King County Plans Reviewed for Code Compliance
 J. Cyprian 05/09/2025
 Issuance of permit or plans, specifications, and computations shall not be construed to be permit for or approval of any violation of any of the provisions of the International Building Codes, Washington State Code, or any other ordinance of King County.
 ADDC24-0584 Construction Plans APPROVED 05-09-2025
 AS NOTED

BARC-Vashon Skate Park
 10500 SW 228th St.
 Vashon, WA. 98070

GENERAL STRUCTURAL NOTES & SPECIFICATIONS

S-1

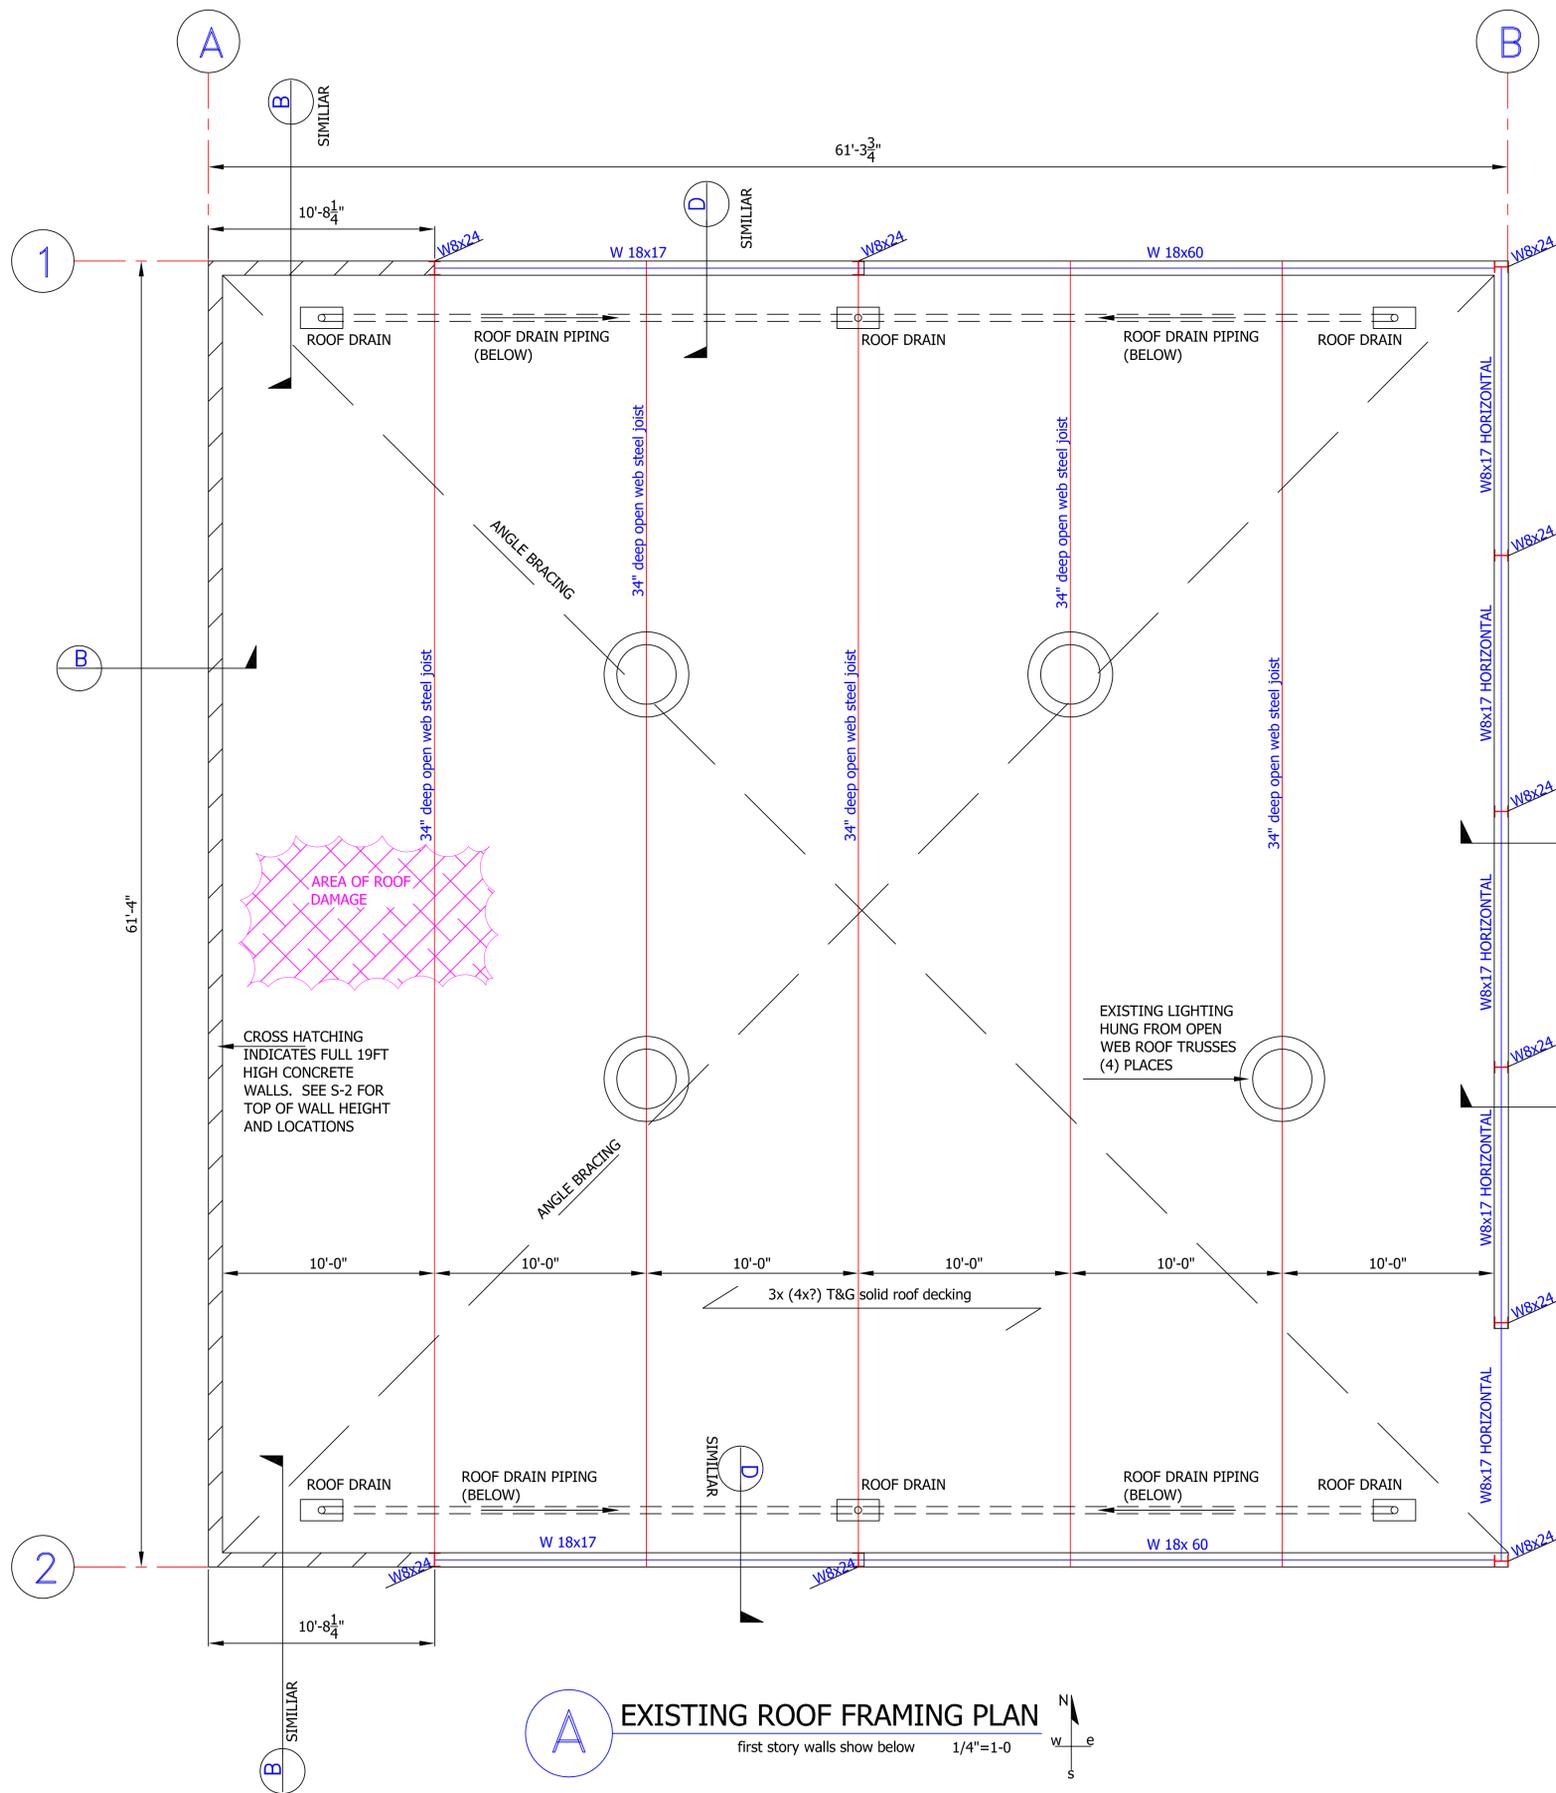
NOTE: MECHANICAL VENTILATION IS REQUIRED. 1,500 CFM (MINIMUM) EXHAUST WITH MOTORIZED DAMPERS, OCCUPANCY/CO2 DETECTOR(S), AND MANUAL/TIMER CONTROL(S) RECOMMENDED. SYSTEM TO BE SUBMITTED UNDER SEPARATE PERMIT, INSTALLED, INSPECTED, AND FINALED PRIOR TO BUILDING FINAL.

TOTAL MAXIMUM ALLOWED LIGHTING WATTAGE INCLUDING NEW AND EXISTING LIGHT FIXTURES CANNOT EXCEED 3,240 WATTS
 GYMNASIUM (EXERCISE AREA) 3,600 S.F. X 0.90 W/S.F. = 3,240 WATTS

WELDING MUST BE PERFORMED BY WABO CERTIFIED WELDERS

EXISTING FLR PLAN

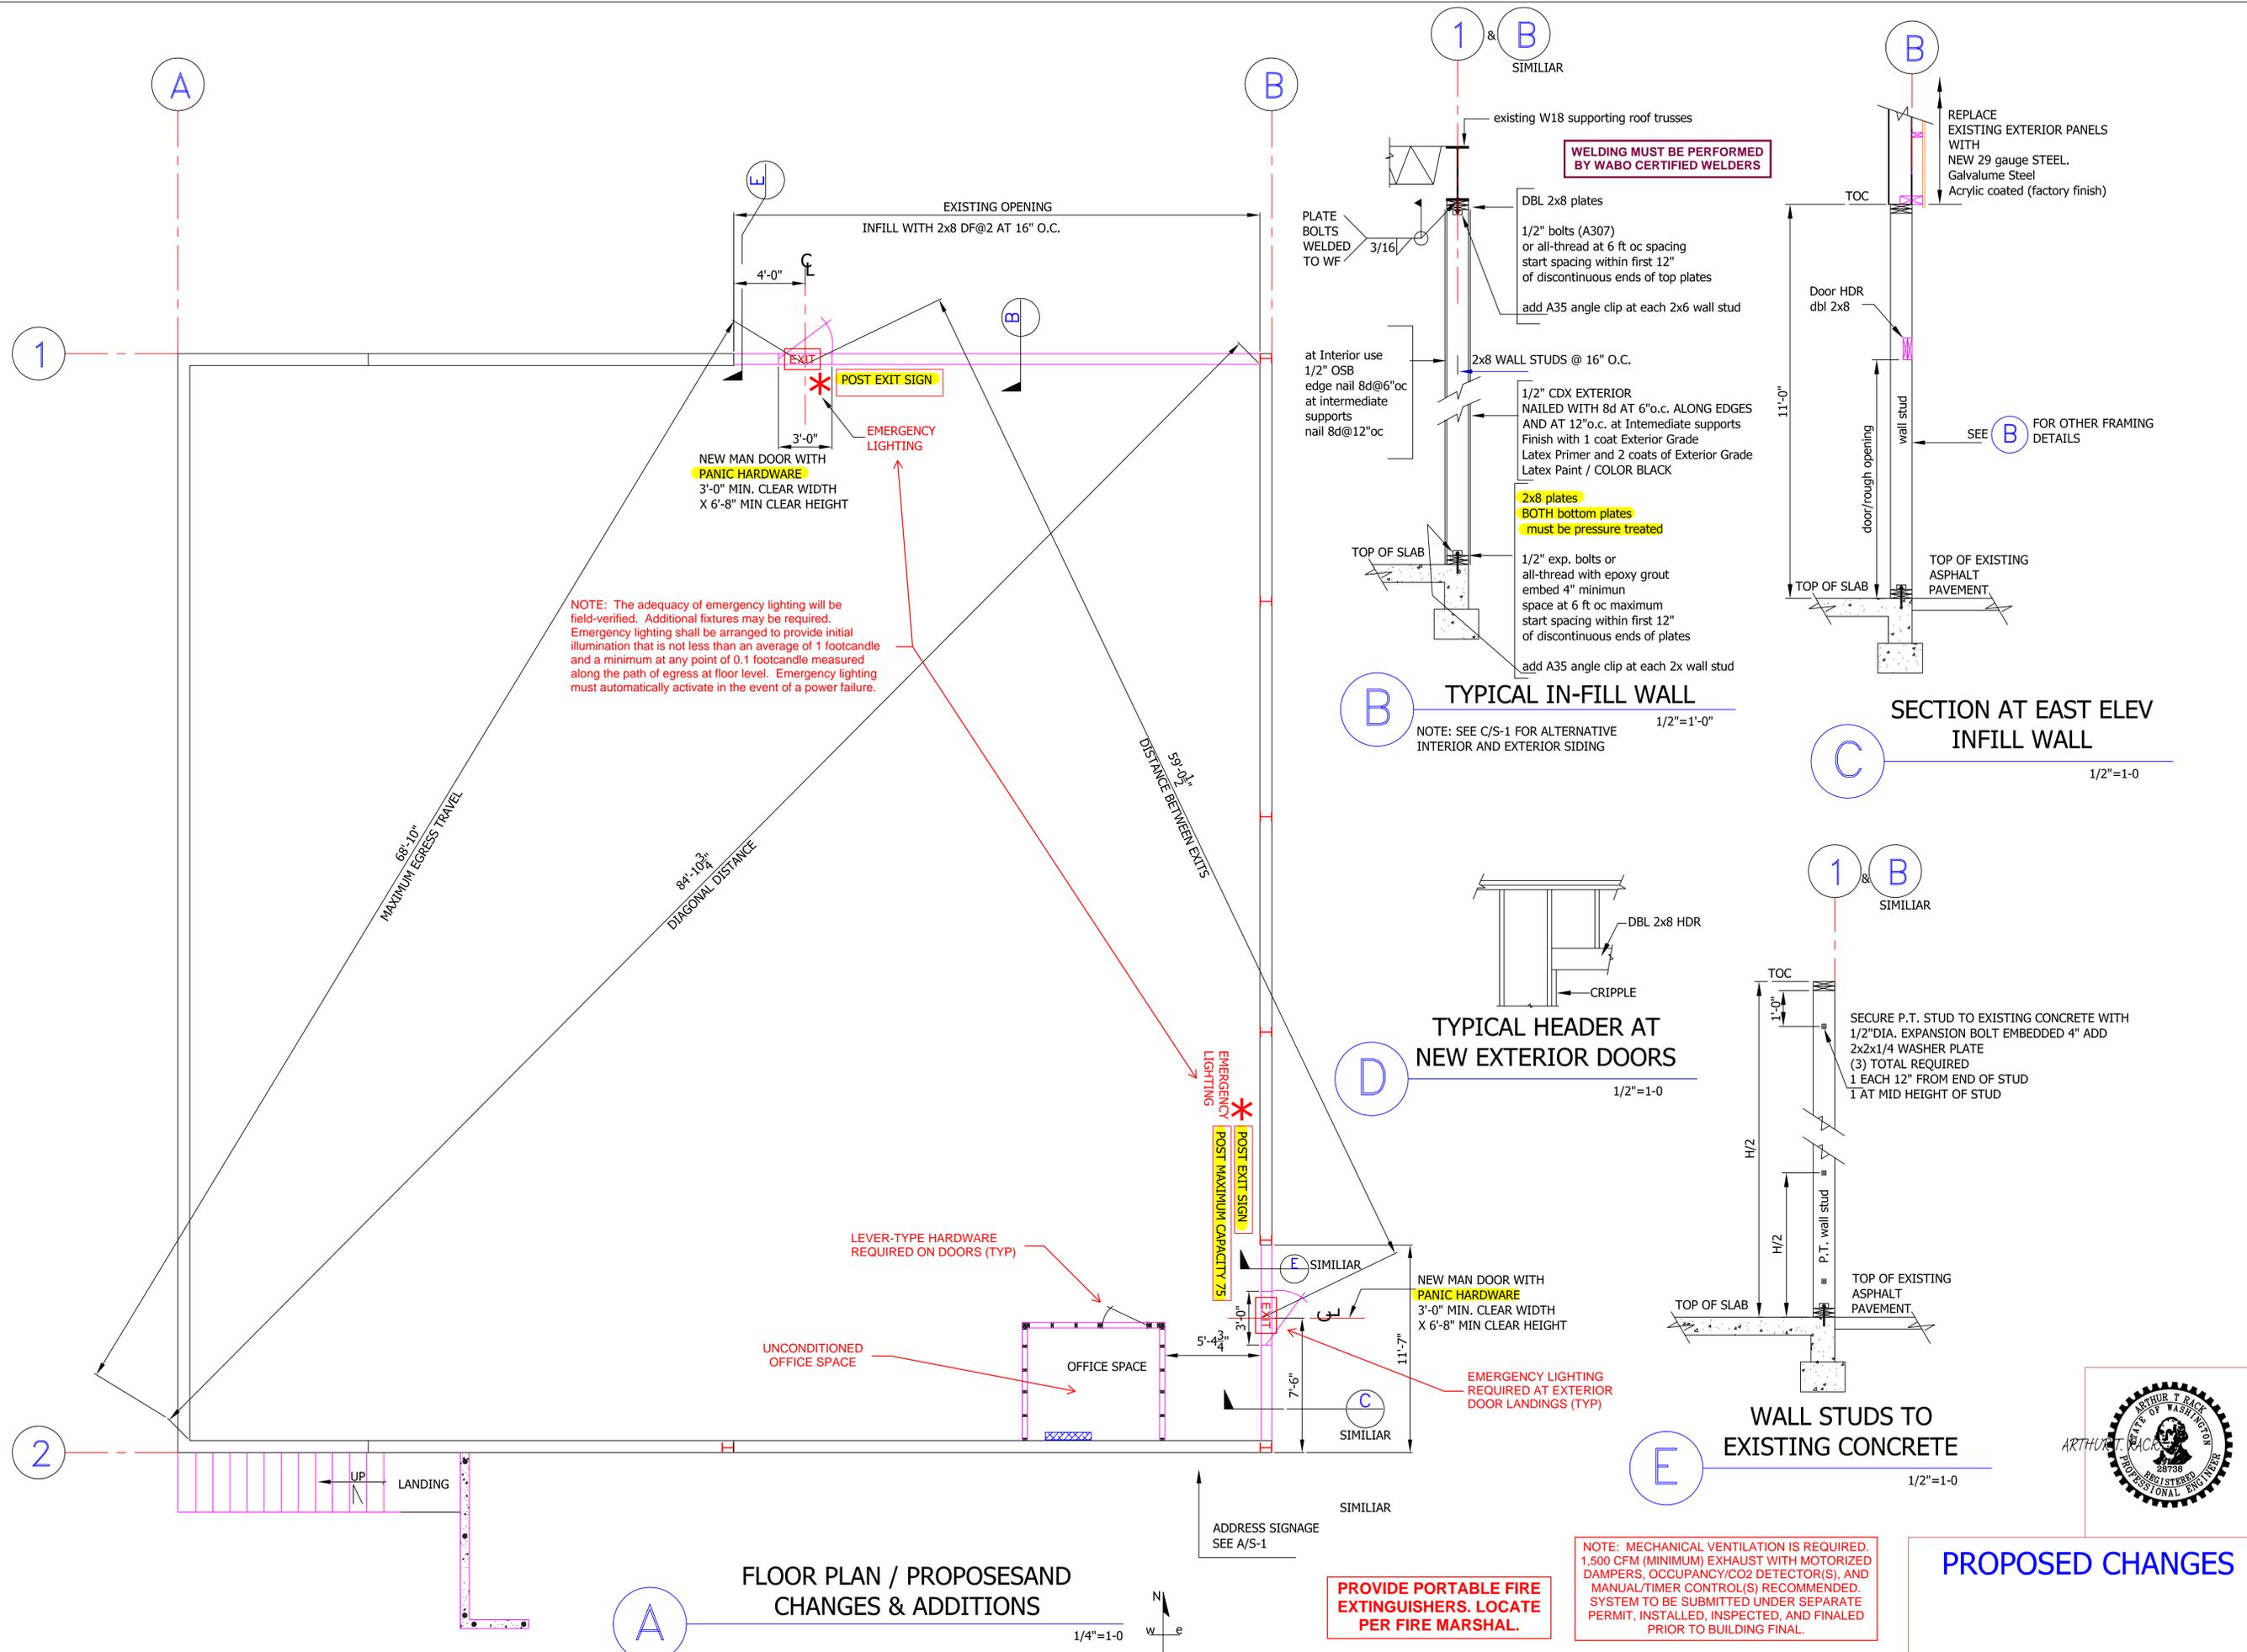
NOTE: The adequacy of emergency lighting will be field-verified. Additional fixtures may be required. Emergency lighting shall be arranged to provide initial illumination that is not less than an average of 1 footcandle and a minimum at any point of 0.1 footcandle measured along the path of egress at floor level. Emergency lighting must automatically activate in the event of a power failure.

PROVIDE PORTABLE FIRE EXTINGUISHERS. LOCATE PER FIRE MARSHAL.

NOTE: MECHANICAL VENTILATION IS REQUIRED. 1,500 CFM (MINIMUM) EXHAUST WITH MOTORIZED DAMPERS, OCCUPANCY/CO2 DETECTOR(S), AND MANUAL/TIMER CONTROL(S) RECOMMENDED. SYSTEM TO BE SUBMITTED UNDER SEPARATE PERMIT, INSTALLED, INSPECTED, AND FINALED PRIOR TO BUILDING FINAL.
